REMARKS

ABOUT THE REJECTION OF DRAWINGS

Annotated Marked-up Drawings

Fig. 1

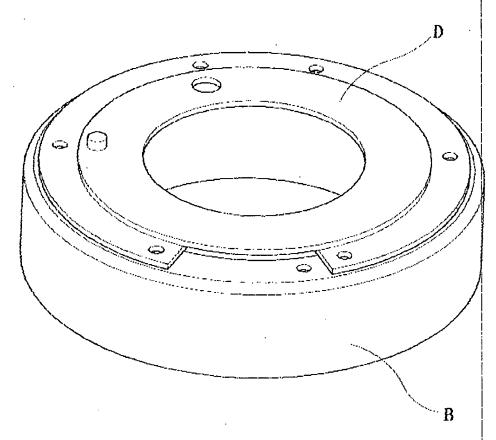
Please amend drawings 1 to 3 as the attached. In the amendment of the drawings, they are indicated with "PRIOR ART". No new matter is added.
